County File # CDDP22-03021

Subject: 8 Multi Family Units
4301 Appian Way, El Sobrante
Planning #: CDDP22-03021
CCCFPD Project No.: P-2022-017264

re: CDDP22-03021 / APN 425-142-030 at 4301 APPIAN WAY, EL SOBRANTE, CA 94803 / Numair Ali

TO: Everett Louie, Project Planner, Department of Conservation and Development
FROM: Larry Gossett, Senior Civil Engineer, Engineering Services Division
SUBJECT: **DEVELOPMENT PLAN PERMIT – DP22-3021**
STAFF REPORT & CONDITIONS OF APPROVAL
(Ali/Appian Way/El Sobrante/APN 425-142-030)
FILE: DP22-03021

Figure 1: CDDP22-03021 Vicinity & Alquist-Priolo Map

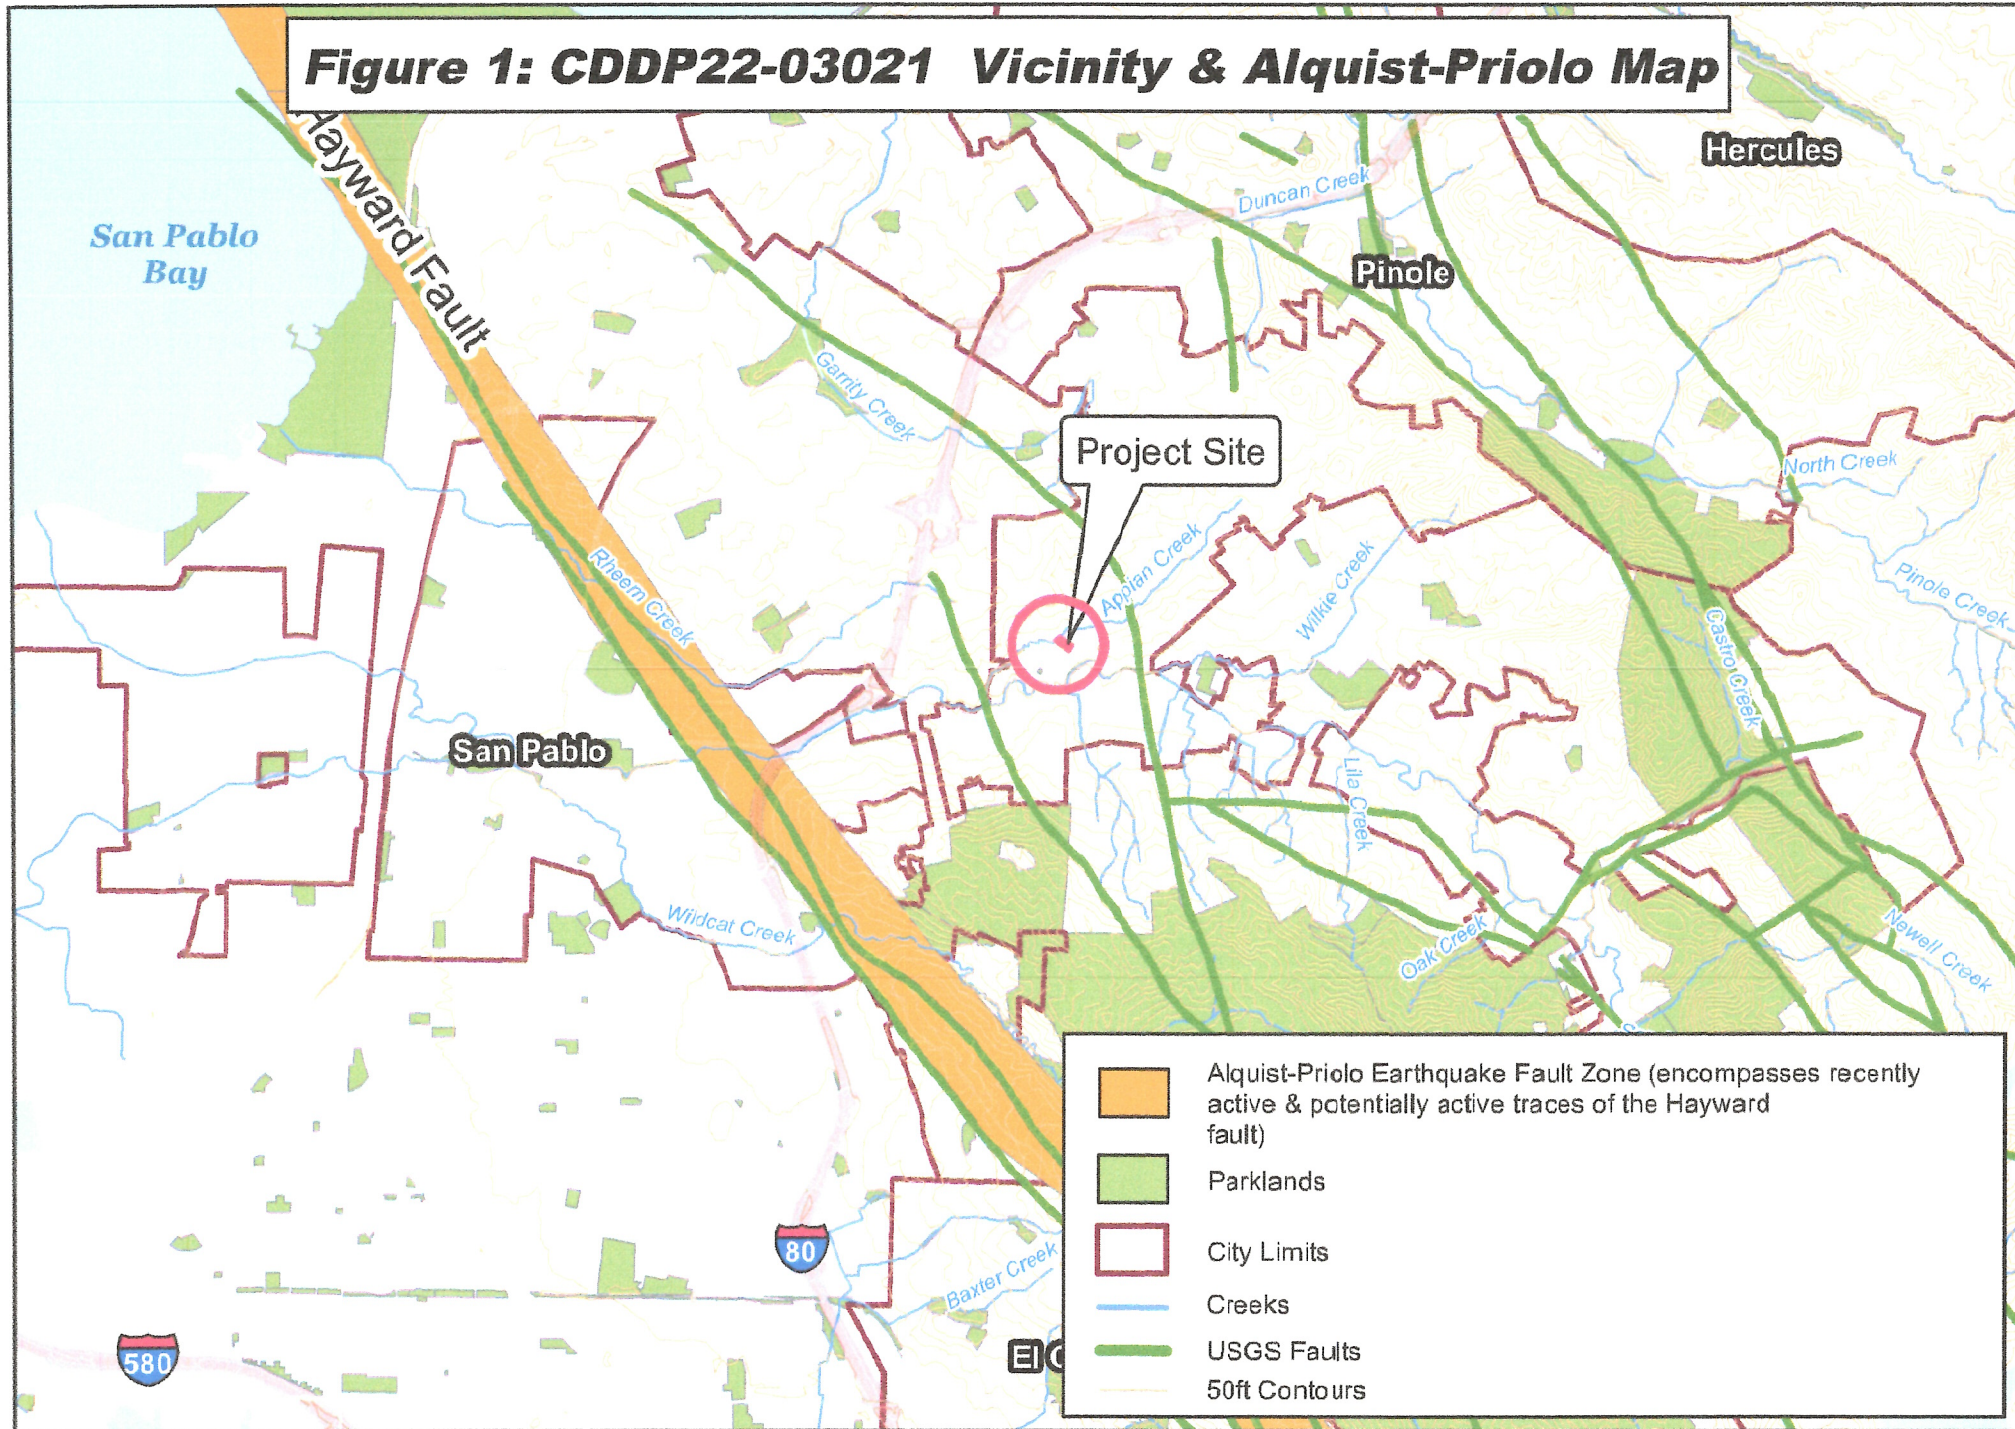
The site is located in the unincorporated El Sobrante area. Figure 1, Vicinity Map, which identifies the location of the site with respect to the local road network, Interstate Highway 80, and boundary of the unincorporated area with nearby cities. The site boundary is shaded in red and is centered within a red bullseye. For reference purposes, Figure 1 also shows the location of the Alquist-Priolo Earthquake Fault Zone (A-P zone) that encompasses recently active and potentially active traces of the Hayward fault. It is the northwest-trending zone (shaded yellow) the trends N30°W and passes approximately 1.2 mi. southwest of the site. The A-P Zone was delineated by the California Geological Survey (CGS). Its width varies depending on the quality of the geologic features available to delineate the fault. The criteria used by the CGS to identify active faults is clear evidence that surface fault rupture has occurred during Holocene time (i.e. during the last 11,000 years±). The Hayward fault is characterized by right-lateral, strike-slip displacement. Evidence of active faulting includes (i) evidence of shearing and offset of Holocene deposits in exploratory trenches logged by geologic consultants for land development projects, (ii) tectonic creep features, (iii) geomorphic features characteristic of active faulting, and (iv) a concentration of small magnitude earthquakes distributed along the mapped fault trace. The last major earthquake on the Hayward fault occurred on October 21, 1868. Previous scientifically oriented investigations of the United States Geological Survey (USGS) utilized absolute aging techniques to establish the recurrence interval and approximate dates the major seismic events on the Hayward fault during the last 700± years. A total of 5 major earthquakes are well documented (circa 1315, 1470, 1630, 1725 and 1868). This historic record indicates a recurrence interval of approximately 140 years±, and it has been nearly 157 years since the last major earthquake. Figure 1 also shows the location of faults that are delineated by a USGS bedrock geology map of Contra Costa County. That particular map does not classify faults by activity status, but it identified location where geologist's have confirmed evidence of faulting within bedrock in the El Sobrante area (bedrock faults are represented by broad green lines).

Figure 3: CDDP22-03021 USGS Quaternary Geologic Map

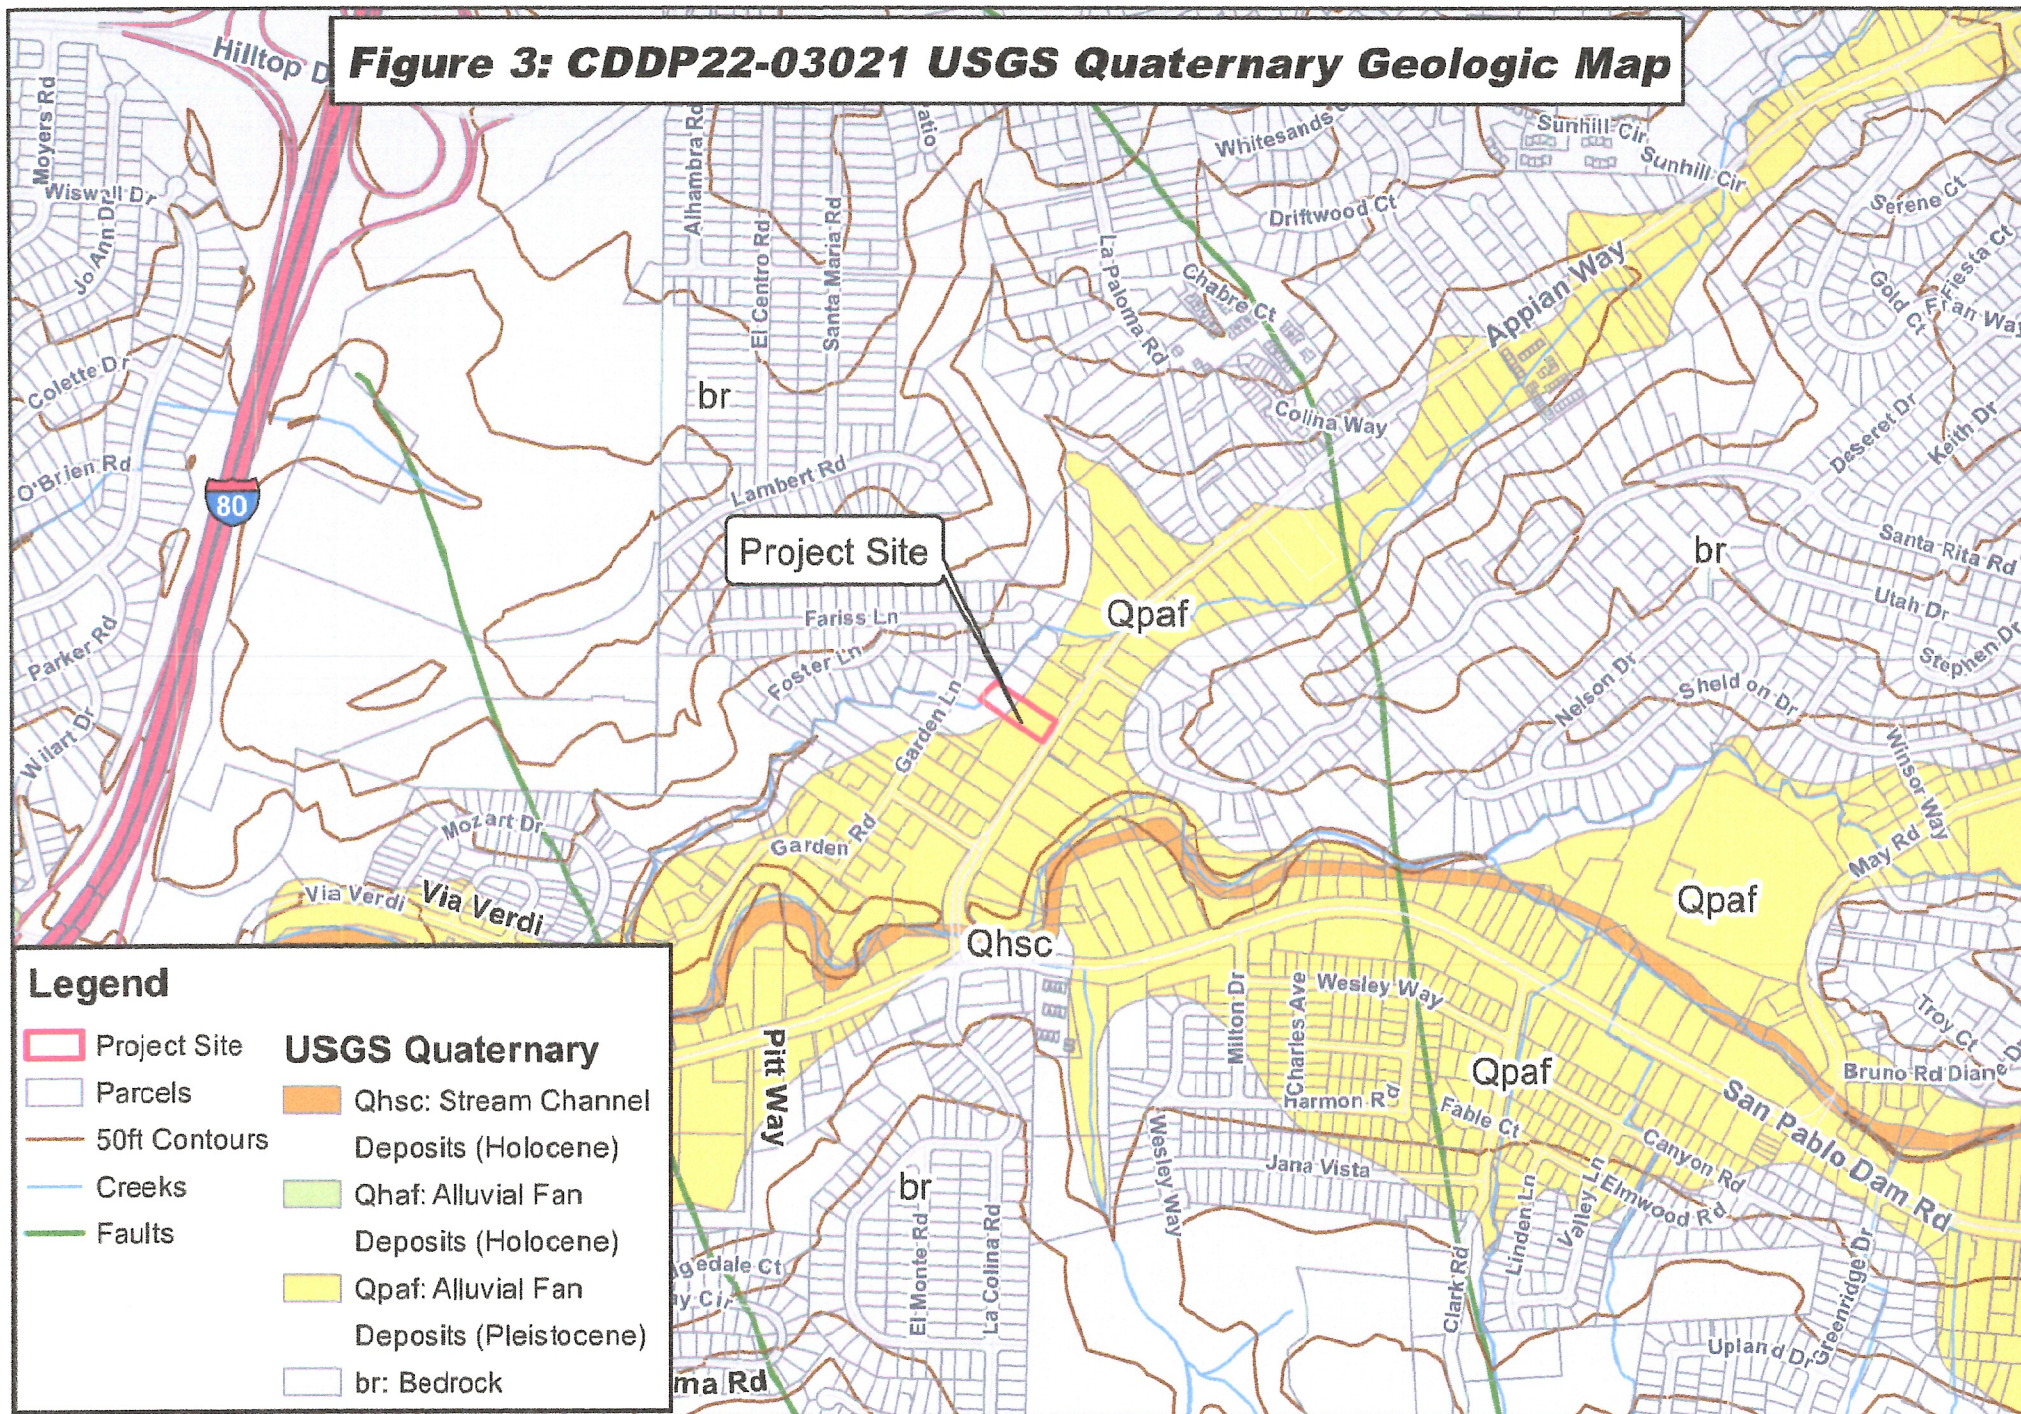
In 1997 the USGS issued a map that divided Quaternary deposits of Contra Costa County into nine (9) categories. The units identified varied in a) age, b) depositional environment and c) engineering properties. Figure 3 presents a portion of this map, showing the surficial deposits that were identified in the vicinity of the project site include the following (i) stream channel deposits of San Pablo Creek and its major tributaries (Qhsc, Holocene age), (ii) fan and fluvial deposits (Qhaf, Holocene age), and (iii) alluvial fan and fluvial deposits (Qpaf, Pleistocene age). Table 4 presents a brief summary of the properties of the units that occur in the vicinity of the Project Site. According to the USGS Map, the central and southeastern portion of the project site is shown to be within the area mapped as Pleistocene alluvium (Qpaf) and the northwest portion of the site is interpreted as bedrock (b) at/ near the ground surface

Figure 4: CDDP22-03021 Seismic Hazard Map

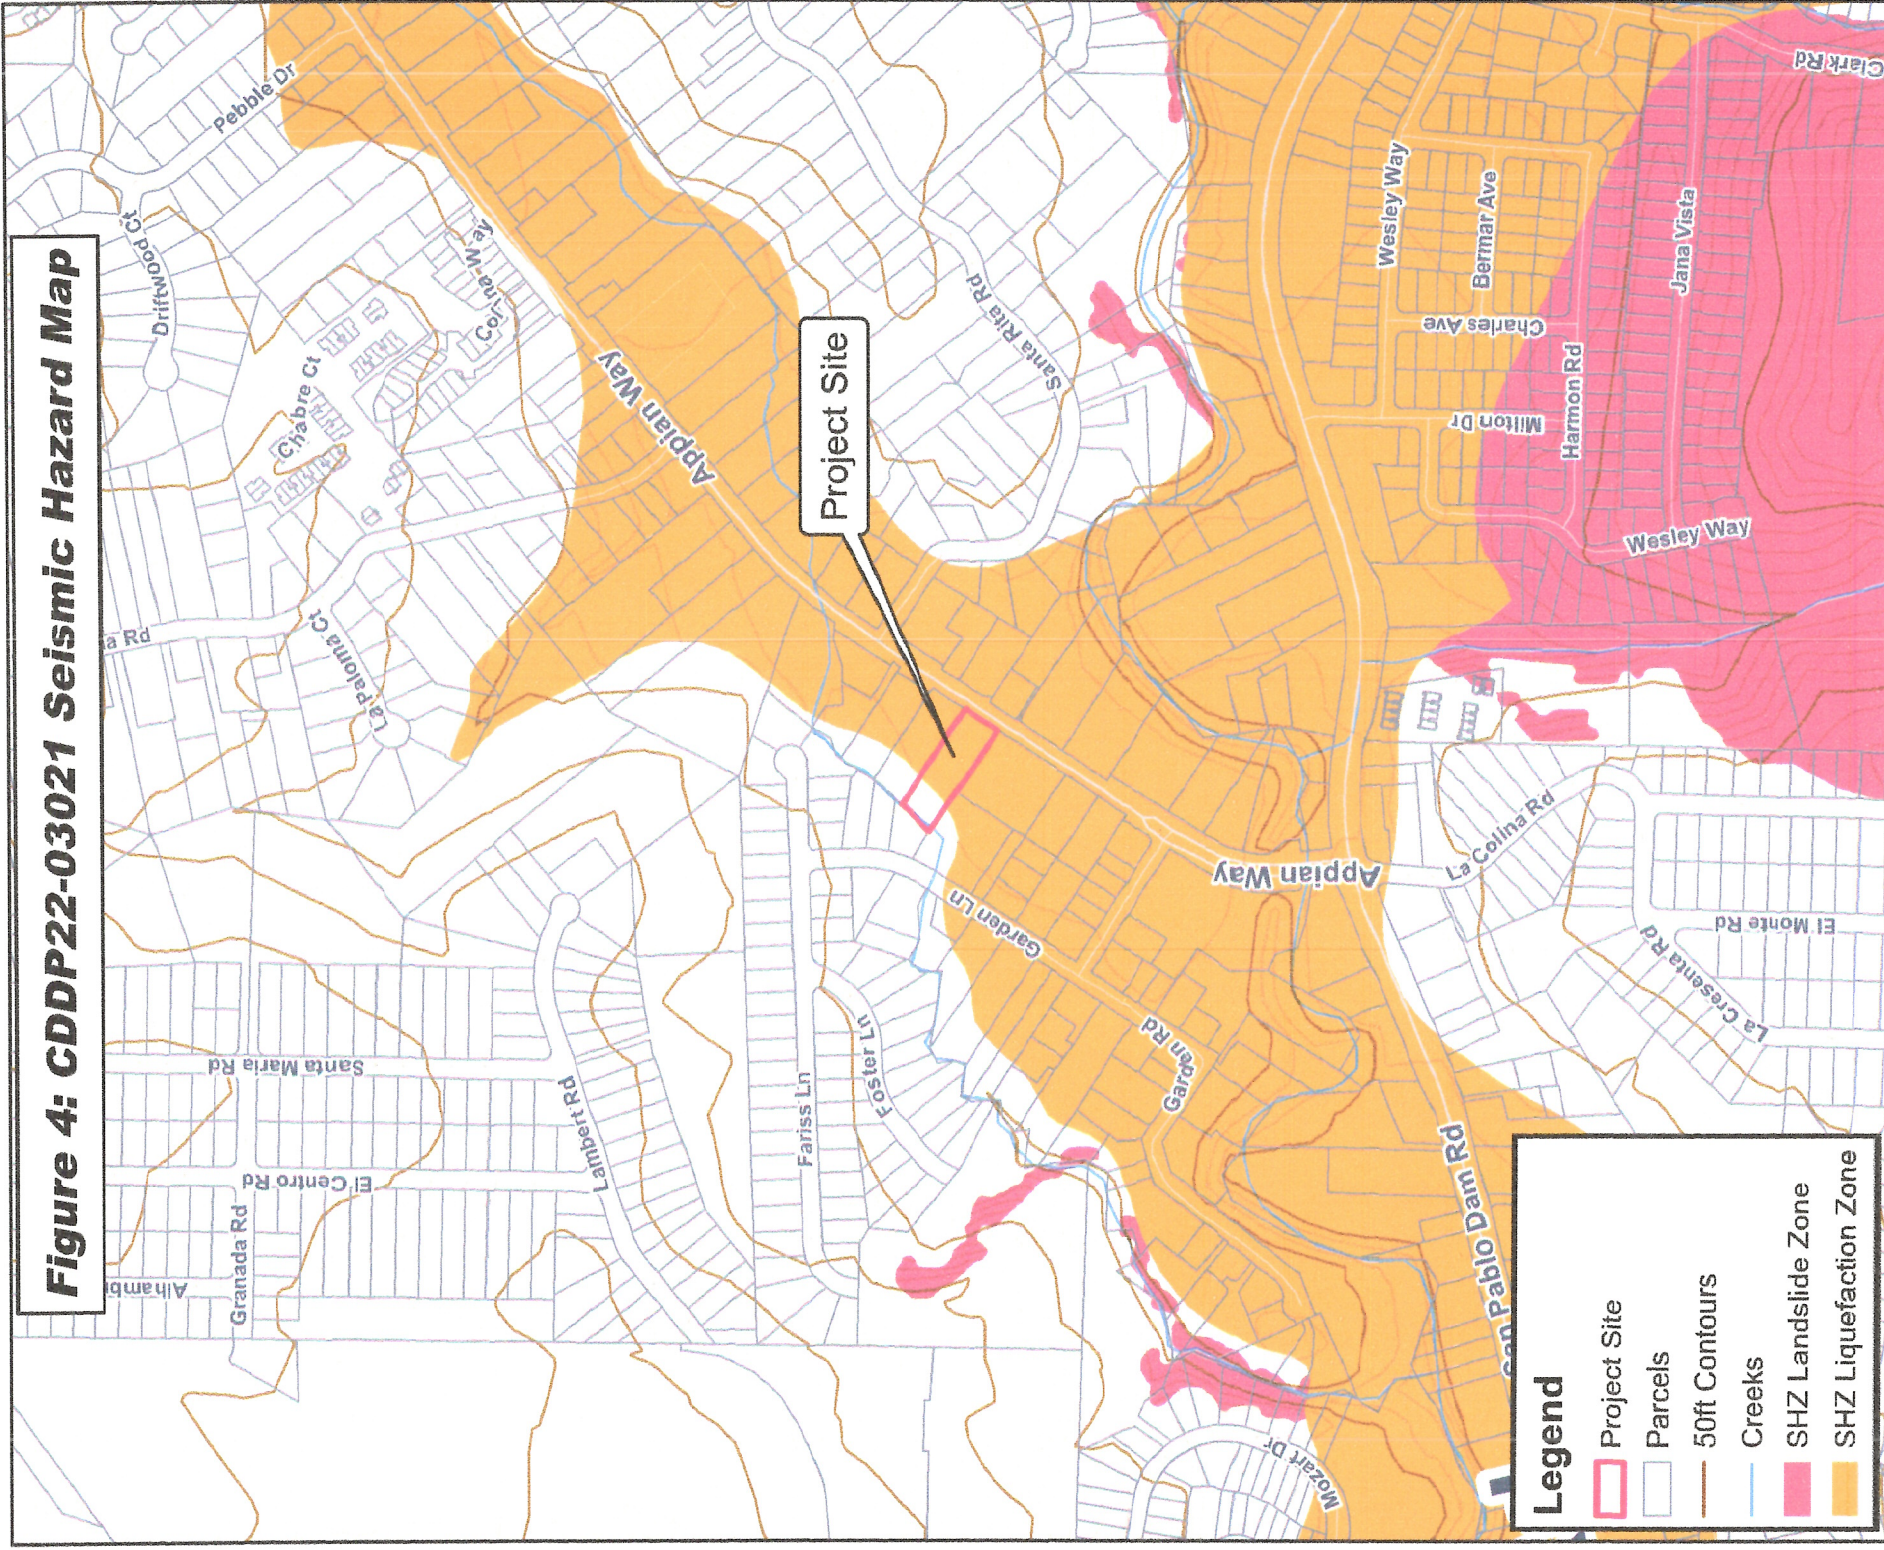
The CGS has issued a *Seismic Hazard Zone* map of the project site and vicinity. The hazard map identifies areas deemed to be at-risk of earthquake-induced liquefaction as well as areas considered to be at-risk of earthquake-induced landslide displacement and other forms of ground failure. As shown in Figure 4, lands deemed to be potentially subject to liquefaction are shaded a yellow-ocher color and the area deemed to be potentially subject to earthquake triggered landsliding and ground failure are shaded a muted, reddish pink color. As shown the central and southeastern portions of the site are indicated to be at risk of liquefaction, which the northwestern portion of the project site is not shown to in a hazard zone. The nearest area of inferred earthquake induced landslide displacement is approximately 850 ft. southwest of the project site.

GEO-1 The evaluation of the liquefaction hazard shall be based on analysis of the CPT data. The SHZ report should include a) project description, b) review of published geologic mapping and seismicity of the El Sobrante area, c) provide justification for all assumptions used as inputs to the computer analysis of liquefaction potential based on analysis of CPT data. The methodology used by the project geotechnical engineers to evaluate liquefaction shall be consistent with guidelines adopted by the California Geological Survey for liquefaction analysis. If the CPT analysis confirms the presence of potentially liquefiable sands in the subsurface, the amount of anticipated total settlement and differential settlement across a building site shall be provided.
